Pacific Gas and
Electric Company

6/15/10 Board Meeting
2010 Integrated Report 303(d)
Deadline: 5/28/10 by 12 noon

RE: PG&E's Comment Letter – 2010 Integrated Report / Section 303(d) List

Figure H-1. Water Segment Delineation for the South Fork Yuba River for Mercury (Hg) Assessment in Fish Tissue

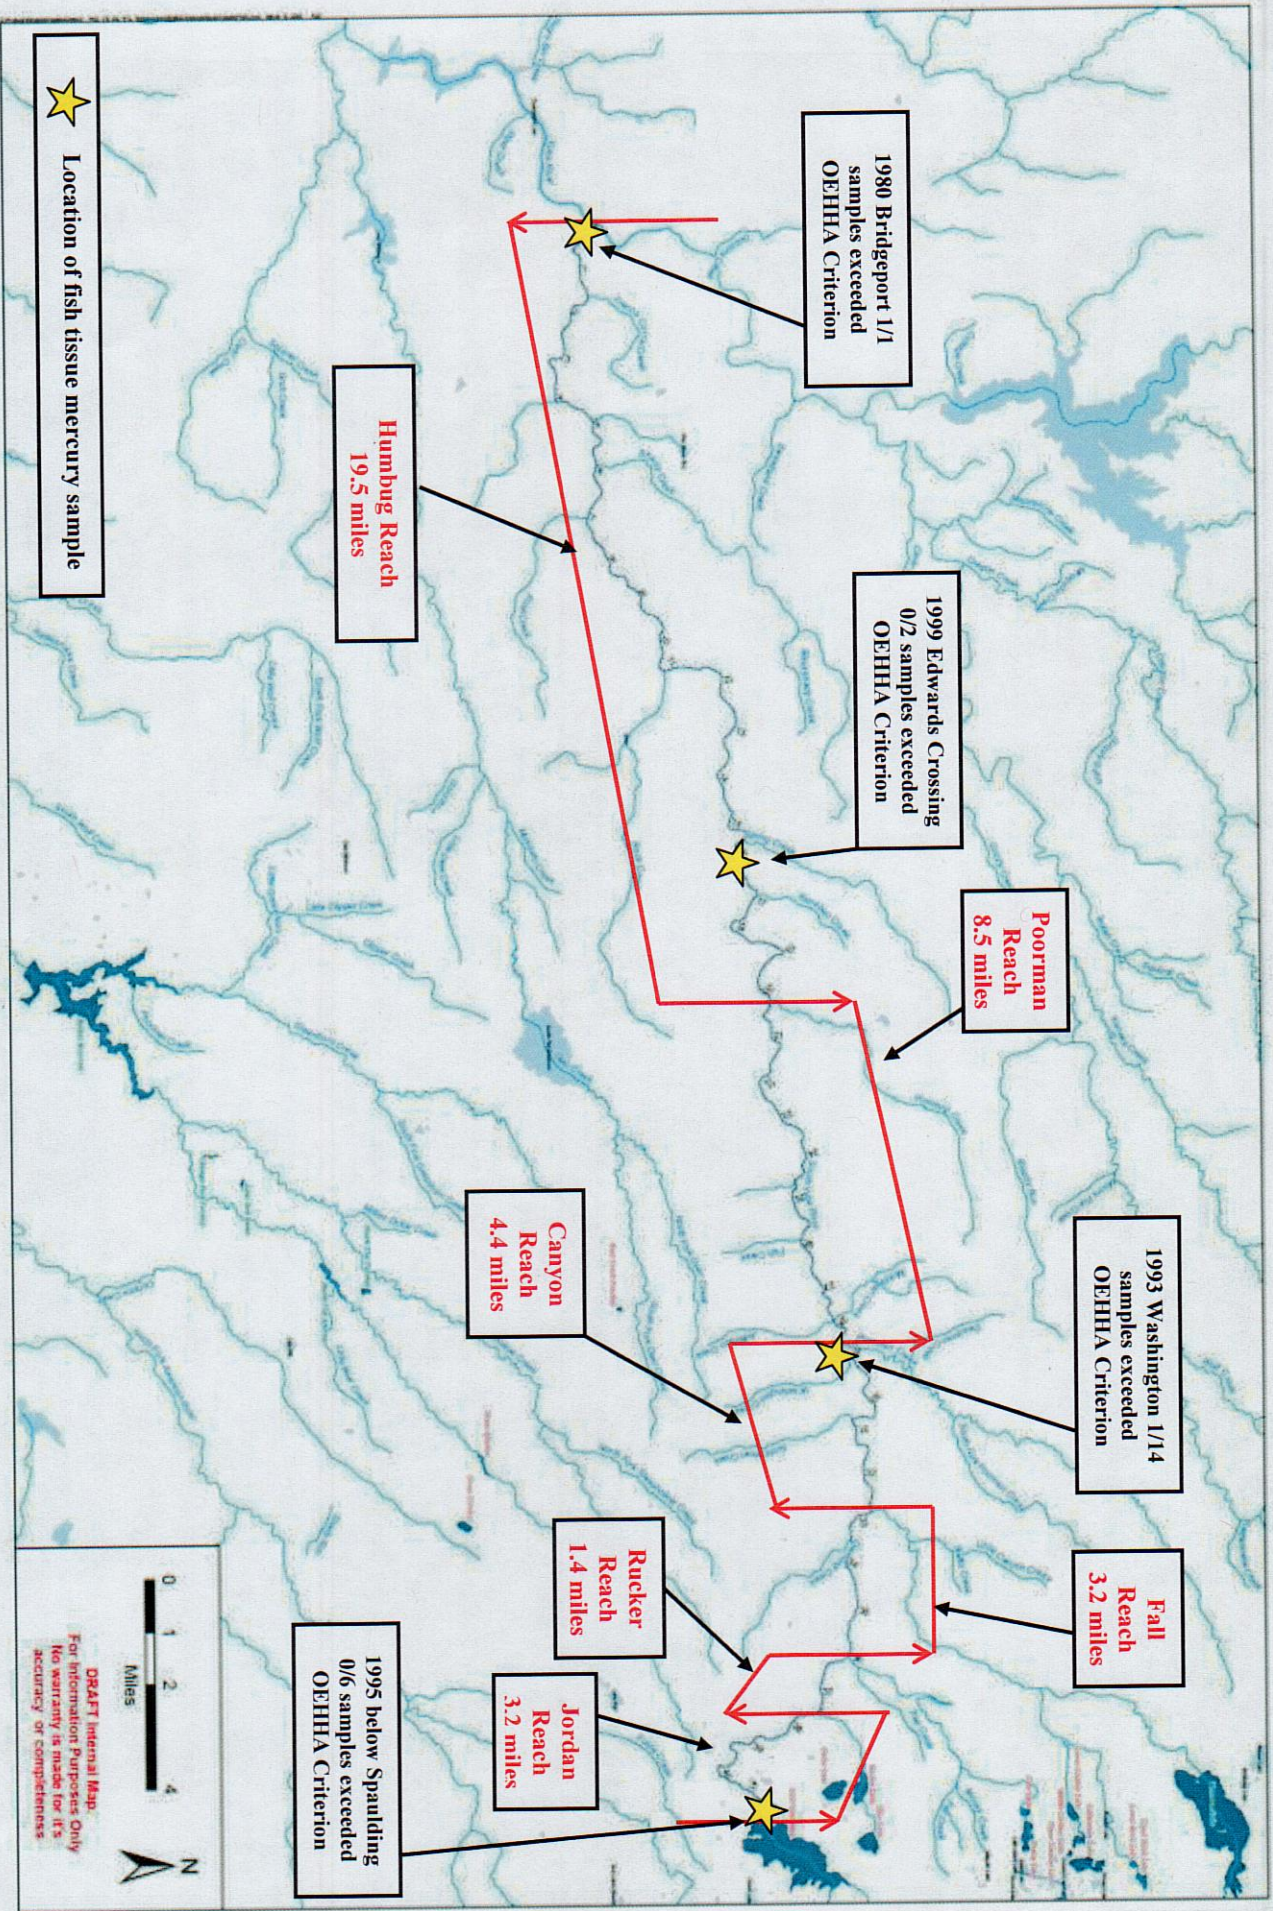
Factsheets for each reach of the South Yuba River (Jordan, Rucker, Fall, Canyon, Poorman, and Humbug) are provided in this submission (see Figure H-1). Factsheets for all of the reaches in the South Fork Yuba River demonstrate that these reaches should not be listed for mercury because known available data do not indicate impairment or there are no known data available to make a determination regarding listing. It should also be noted that there are two other short reaches below Lake Spaulding; the "South Yuba below Spaulding Dam Reach" which is 0.2 miles long and goes from Spaulding Dam to Spaulding No. 2 Powerhouse, and the "South Yuba below Spaulding No. 2 Powerhouse Reach" is 0.7 miles and goes from PH #2 to Jordan Creek confluence. However, there are no data available within either of these very short reaches, and they are not included in the factsheets provided by PG&E below.

There is no justification for listing any river segment of the South Yuba River on the 303(d) list of impaired water bodies.

Figure I-1. Water Segment Delineation for the South Yuba River for Water Temperature Assessment

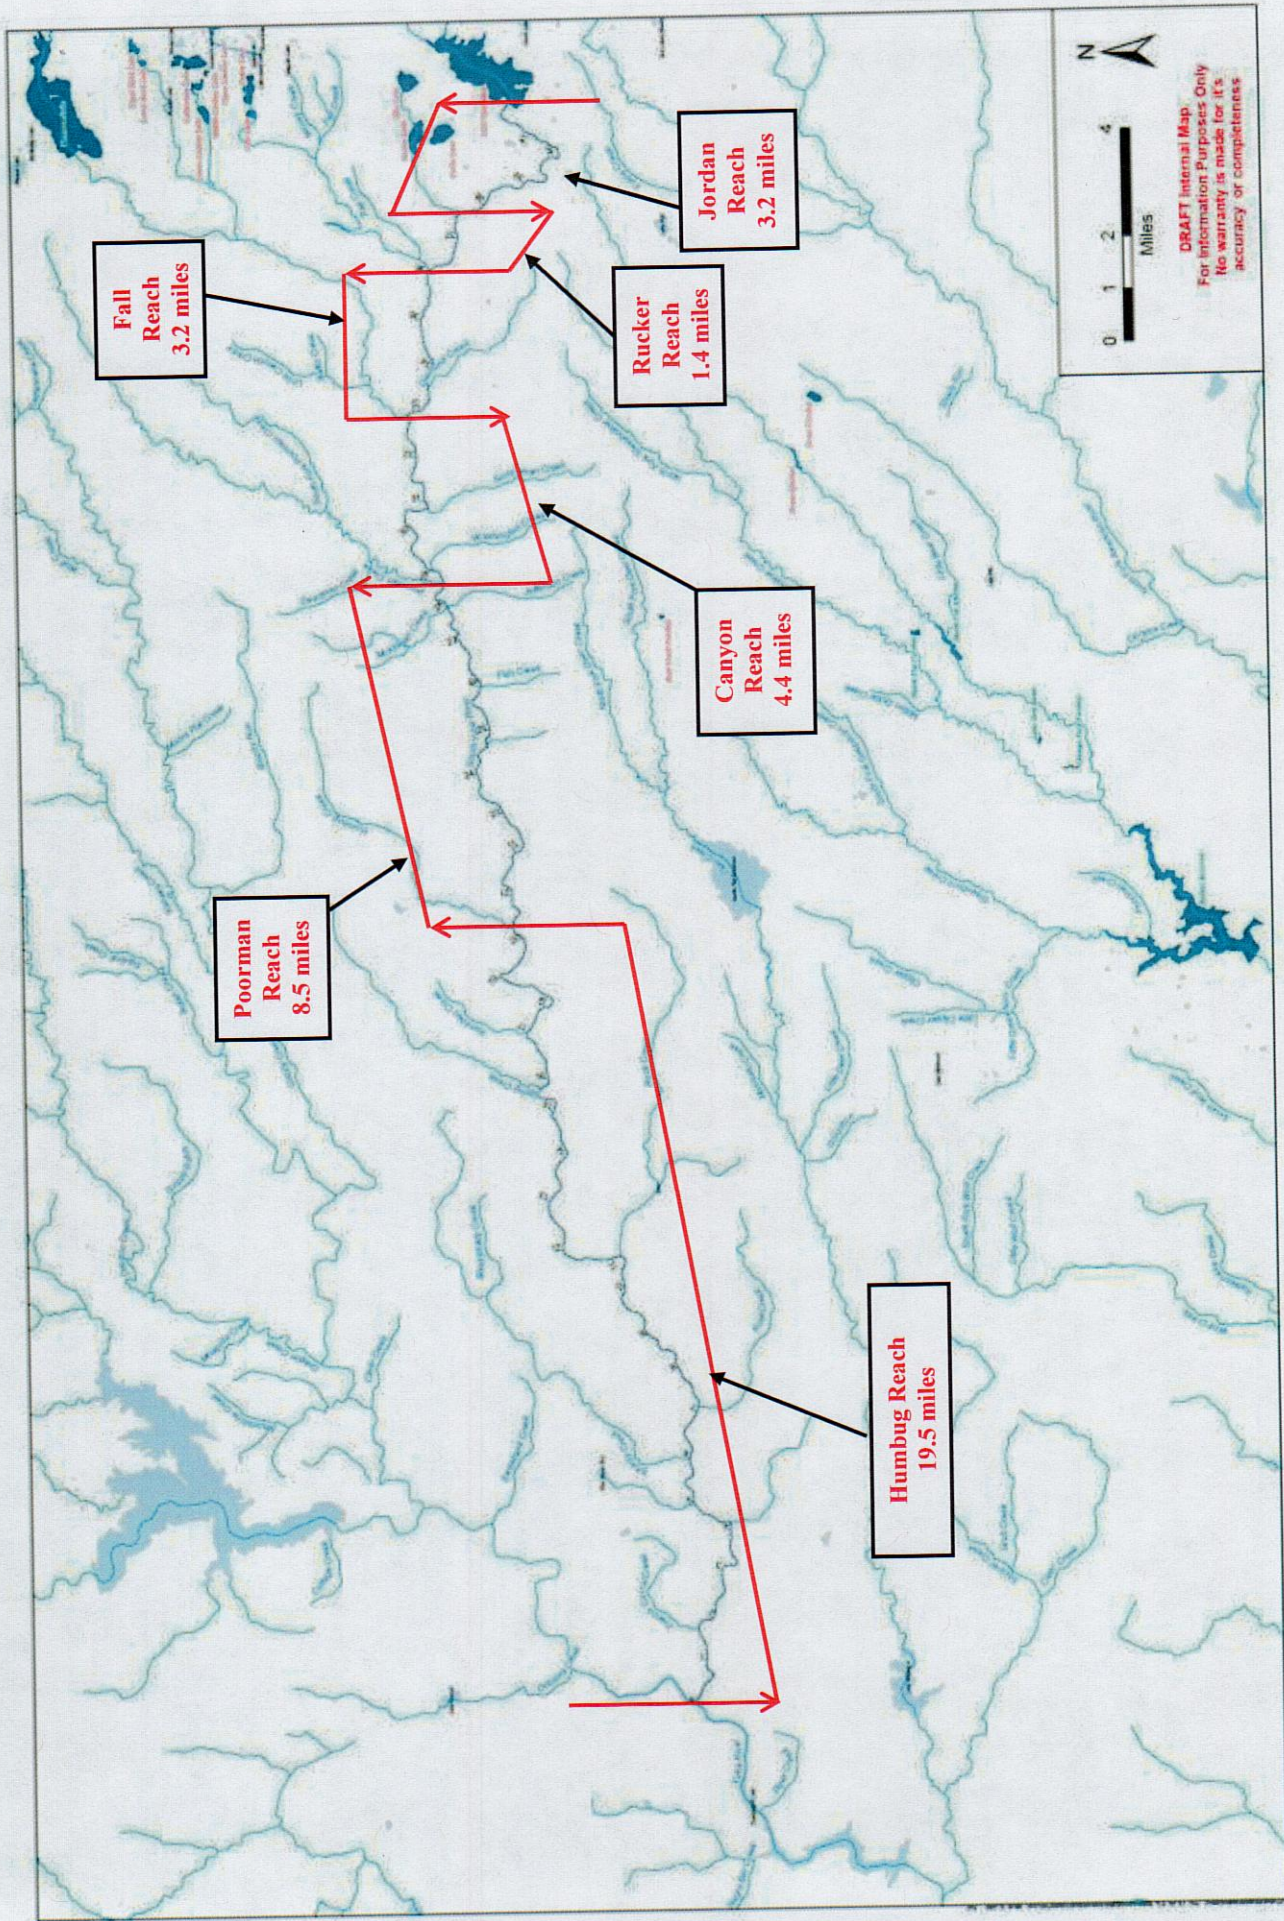
Changes in elevation also result in changes in relative air temperatures that will be encountered within each reach (i.e., relative air temperatures will increase with decreases in elevation and the influence of these warmer air temperatures will be greater in the downstream reaches). Thus, the South Yuba River (below Lake Spaulding to Englebright Reservoir) should be evaluated by segment, and we have outlined the specific segments and the data correlated with each segment in the following discussion. PG&E has provided factsheets for each reach of the South Yuba River (Jordan, Rucker, Fall, Canyon, Poorman, and Humbug) in this submission. It should also be noted that there are two other short reaches below Lake Spaulding; the "South Yuba below Spaulding Dam Reach" which is 0.2 miles long and goes from Spaulding Dam to Spaulding No. 2 Powerhouse, and the "South Yuba below Spaulding No. 2 Powerhouse Reach" is 0.7 miles and goes from PH #2 to Jordan Creek confluence. However, there are no data available within either of these very short reaches, and they are not included in the factsheets provided by PG&E below. PG&E's factsheets include information regarding the health of each river segment based upon the most recent readily available data from the specific water segments (see Figure I-1).

Factsheets for each reach of the South Yuba River (Jordan, Rucker, Fall, Canyon, Poorman, and Humbug) are provided in this submission (see Figure I-1). Factsheets for all of the reaches in the South Fork Yuba River demonstrate that these reaches should not be listed for water temperature because known available data do not indicate impairment or there are no known data available to make a determination regarding listing. There is no justification for listing any river segment of the South Fork Yuba River on the 303(d) list of impaired water bodies for water temperature.
